Product/Process Change Notice (PCN)

PCN #: PCN_IndTI_20150901

Product Affected: WE-TI 5075 series
WE-TI 6065 series
WE-TI 1014 series

Label example for pad printing
(13th digit marked in red)

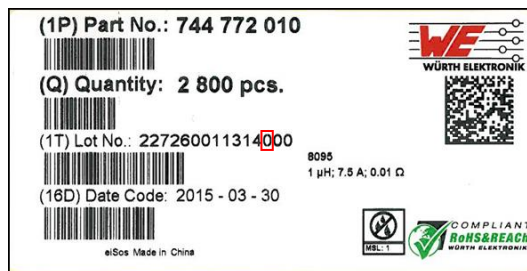
- 1.) All electrical and mechanical properties of the parts will remain the same.
- 2.) Pad-, Inkjet- and Laser-Printing will be used from now on.
- 3.) Printing method can be identified on the label by the 13th digit in the lot number.

Lot.-No. for Pad-Printing: xxxxxxxxxxxx0xx
Lot.-No. for Inkjet-Printing: xxxxxxxxxxxx1xx
Lot.-No. for Laser-Printing: xxxxxxxxxxxx2xx
